COMMUNICATION EQUIPMENT MAINTENANCE BULLETIN

SECTION 9. TRANSMITTING EQUIPMENT

FIGURE 2.—Template for relocation of TDN capacitor C-1.

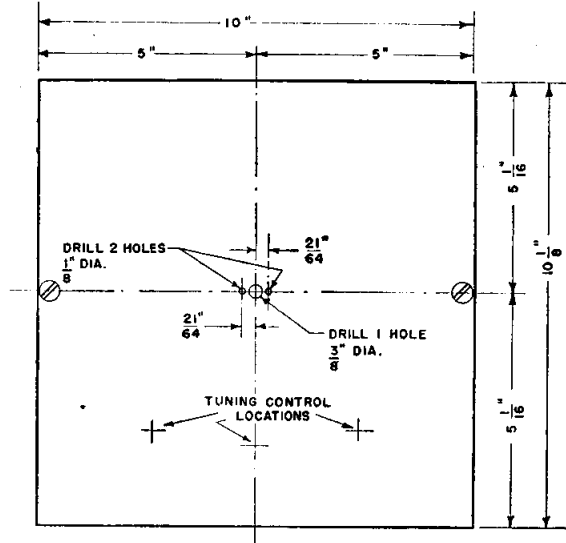
1. Drill 3 holes in panel for relocation of C-1.
2. Install insulated bushing in shaft hole of original position of C-1 for lead from crystal socket to

FIGURE 2.—Model TDQ with the transmission line filter installed.

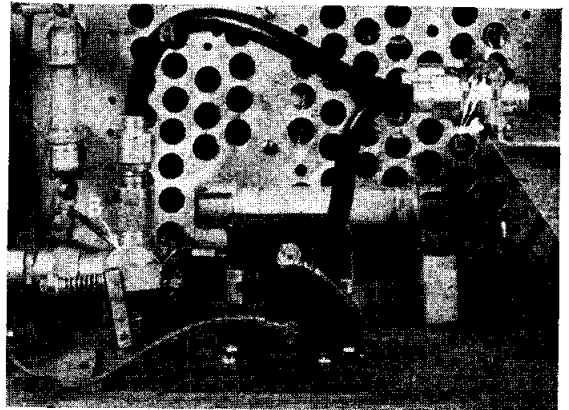
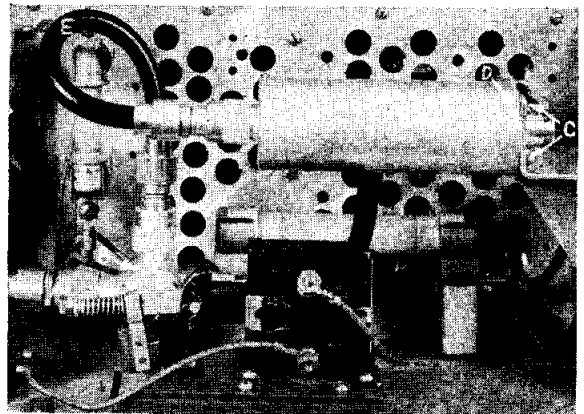
The filter and associated male cable connector replace the existing cable connector between the antenna switch and the outlet chassis fitting. This is shown in Figures 1 and 2.

FIGURE 1.—New CAUTION nameplate for model TDQ transmitters.

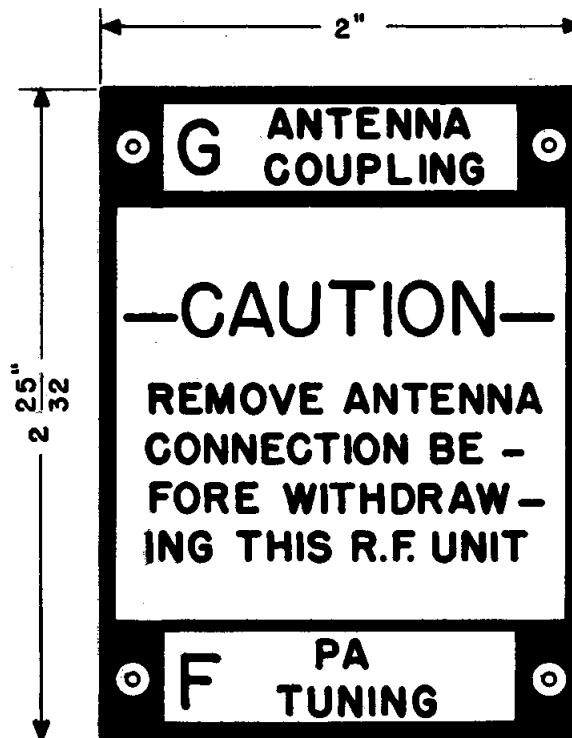
Procedure.—Remove the G ANTENNA COUPLING and F PA TUNING existing nameplates. Install the new nameplate using the same mounting holes. Figure 1 illustrates the design of the new nameplate.

FIGURE 1.—Addition of a send-receive relay.

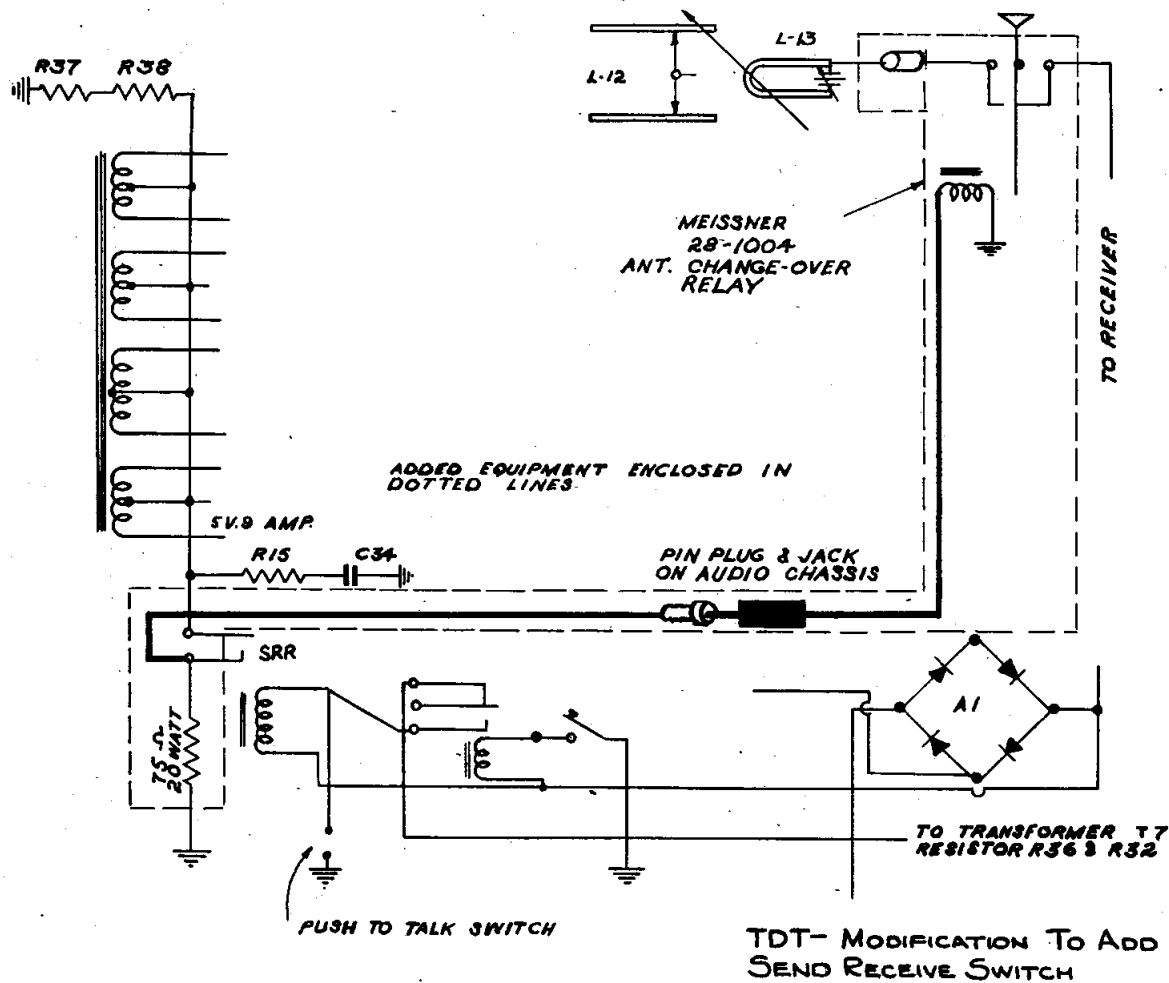
Procedure.—Connections should be made as shown in Figure 1, as follows:

(3) Remove the original antenna fittings from the cover of the model TDT transmitter and substitute a length of 50-ohm solid dielectric cable to connect the output of the transmitter to the antenna relay as shown in Figure 1.

FIGURE 1.—Model TEB Shaper Control Schematic Diagram Simplified.

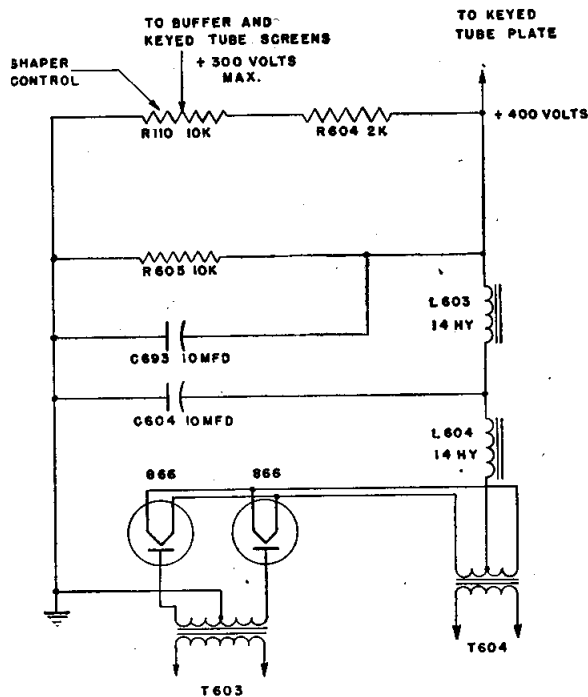
The shaper circuit in question is shown in figure 1.

NOTE.—The diagram below shows the circuit after resistors have been installed in accordance with the manufacturer's diagram. 4/1/51.

FIGURE 1.—Modified tap-changing timing relay K-249.

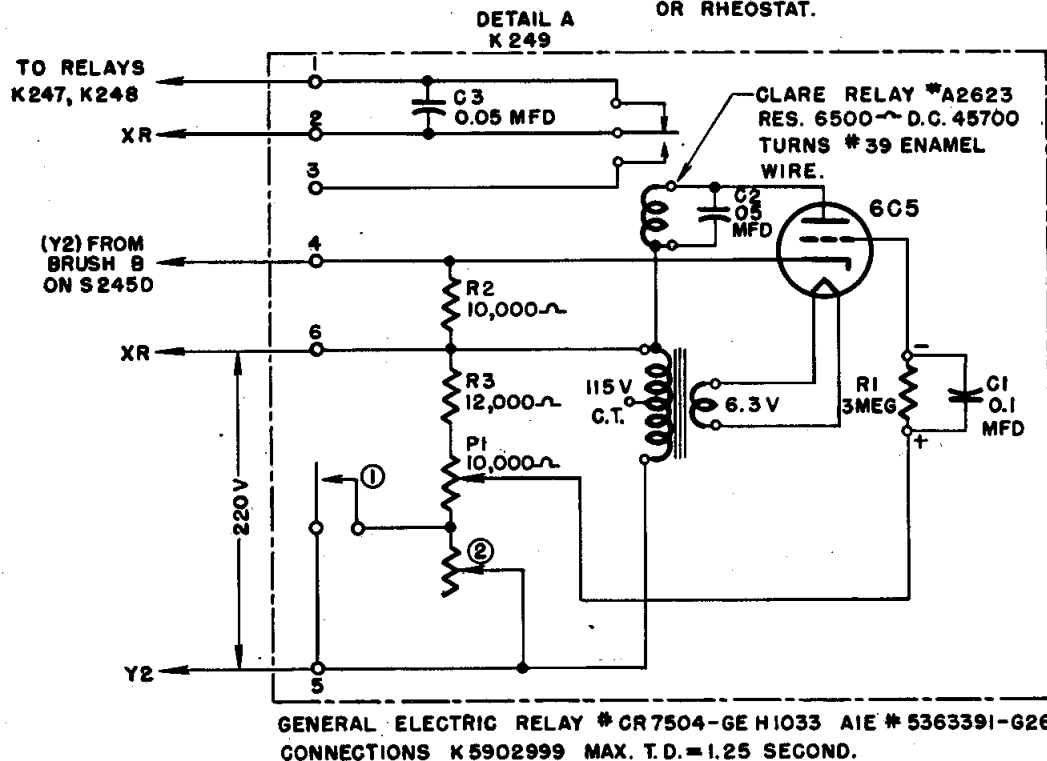
To effect satisfactory operation, the timing circuit has been modified to provide two automatically selected timing adjustments, one for clockwise rotation of the tap-changer mechanism and the other for counterclockwise rotation. The circuit modification is shown in figure 1.
